# Access Compliance Report

## Public Rights-of-Way

Intersection ID: 27755	Main Street: BALLANTYNE_CROSSING_AV	Cross Street: NOLEN_LN	Location:	E
ADA ID: D88B825ADD44	Ramp Type: BlendTrans1	Initial Pass/Fail: Fail	Overall Compliance: No	Severity Score: 12.5
Codes/Mitigation Info/Possible Solution		Field Measurements/Component Compliance

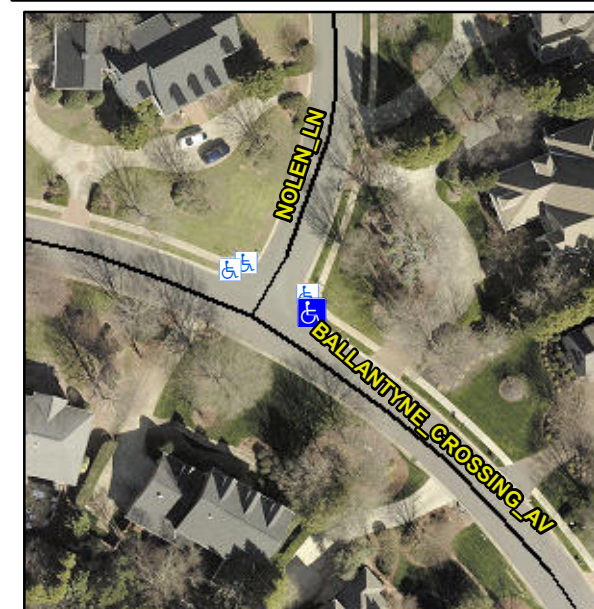
**Not Found, R304.5.3**

Compliance	Description	Data	Compliance	Description	Data
N/A	Ramp Length (in)	49.0	Yes	BlendTrans Slope (%)	3.2
Yes	Ramp Width (in)	50.0	No	BlendTrans XSlope (%)	5.4
N/A	Flare Type LT	N/A	N/A	Flare Type RT	N/A
N/A	Flare Slope LT (%)	N/A	N/A	Flare Slope RT (%)	N/A
N/A	Flare Traversable LT?	N/A	N/A	Flare Traversable RT?	N/A
N/A	Landing Length (in)	N/A	N/A	DWS Provided?	N/A
N/A	Landing Width (in)	N/A	N/A	DWS Contrast?	N/A
N/A	Landing Slope (%)	N/A	N/A	DWS Length (in)	N/A
N/A	Landing X Slope (%)	N/A	N/A	DWS Full Width?	N/A
N/A	Landing Curb? (Y/N)	N/A	N/A	DWS Offset (in)	N/A
N/A	Shared Landing?	N/A			
N/A	Gutter Ponding?	N/A	N/A	Gutter Slope (%)	N/A
N/A	Gutter Lip Ht (in)	N/A	N/A	Gutter X Slope (%)	N/A
N/A	Painted X Walk1?	No	N/A	Painted X Walk2?	N/A
	X Walk 1 Direction	To SW		X Walk 2 Direction	N/A
	X Walk 1 Width (in)	N/A		X Walk 2 Width (in)	N/A
	X Walk 1 Slope (%)	3.5		X Walk 2 Slope (%)	N/A
	X Walk 1 X Slope (%)	6.6		X Walk 2 X Slope (%)	N/A

N/A	Ramp inside XWalk1?	N/A	N/A	Ramp inside XWalk2?	N/A
	Road Slope (%)	6.6		Clear Space?	N/A
	Road X Slope (%)	3.5	N/A	Clear Space to XWalk (in)	N/A
N/A	Any Obstructions?	N/A	N/A	Storm Grate/Utility Hazard?	N/A
	Obstruction Type			Storm Grate/Utility Type	
		N/A			N/A
			Yes	Surface Condition? (G/P)	Good
			No	Curb Slope (%)	12.4

**Remove & Replace Curb Ramp With Two New Directional Ramps or Equivalent.**
